CITY OF KIRKLAND NOTICE OF DECISION

Permit application: MS 3 Short Plat ([SUB15-01532](#))

Location: [12805 NE 112th Street](#)

Project description: Subdivide a 13,919 square foot parcel into 2 single family lots in the RSX 7.2 Zone. The applicant is proposing to retain the existing house on proposed Lot 1. An integrated development plan is not included with the short plat (see Attachments 1 and 2).

Tree Map

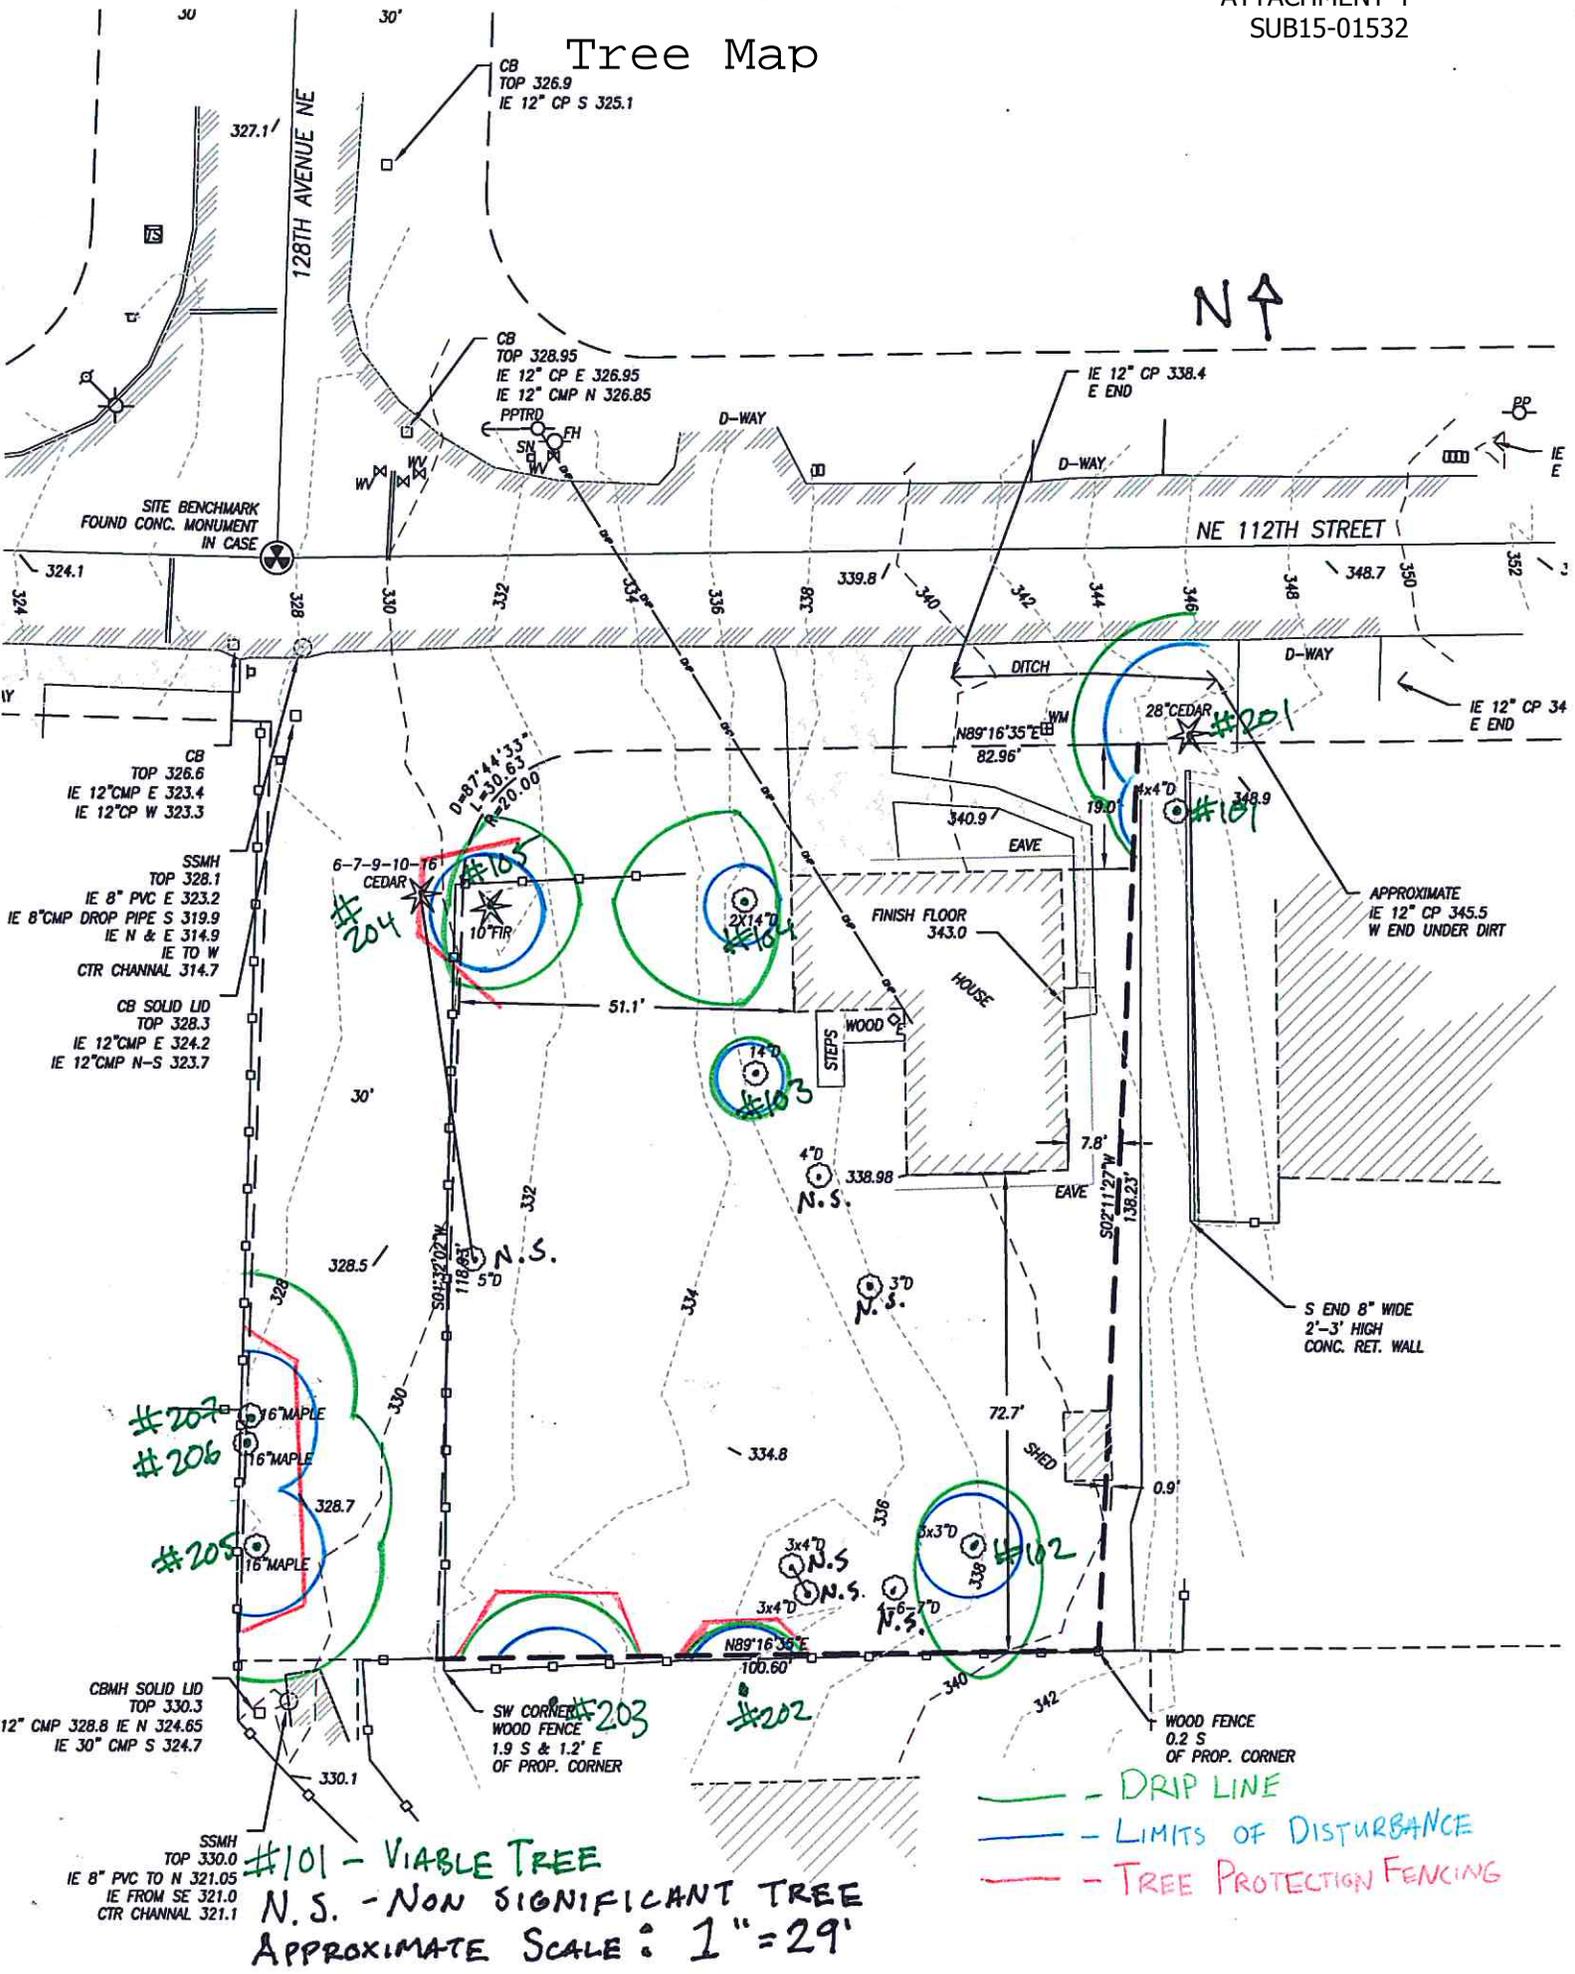
There are two significant trees labelled as “non-significant” in the arborist report (Dogwood and Mtn. Ash). Both trees are located within the building footprint and are likely to be removed. Tree #102 is a mountain ash not an Oregon ash as indicated in the report.

The only high retention value tree on-site is #105. This tree will likely need to be removed based on the requirement for storm drainage line to run through its root zone.

ROW trees: Tree #204 is in good health with a canopy interspersed with tree #105. Like tree #105, it will likely have to be removed to allow for the storm drainage line to be located in its root zone.

Tree #207 has a main stem that has cracked and poses a high risk to the public path. This stem is on the east side of the tree and should be pruned prior to construction to abate risk. Removing this stem will remove a significant portion of the live crown. This tree should be re-assessed 1-year post-construction for long term viability.

To protect trees #205 – 207 the proposed pedestrian walkway should be constructed at or above grade. Small equipment should be used when working in close proximity to the trees. Mulch should be added around the base of the trees after construction. Tree protection fencing should be erected adjacent to the pedestrian walkway.

No trees are to be removed with an approved short plat or subdivision permit. Based on the approved Tree Retention Plan, the applicant shall retain and protect all viable trees throughout the development of each single family lot except for those trees allowed to be removed for the installation of the plat infrastructure improvements with an approved Land Surface Modification permit. Subsequent approval for tree removal is granted for the construction of the house and other associated site improvements with a required Building Permit. The Planning Official is authorized to require site plan alterations to retain High Retention value trees at each stage of the project. In addition to retaining viable trees, new trees may be required to meet the minimum tree density per KZC Section 95.33.
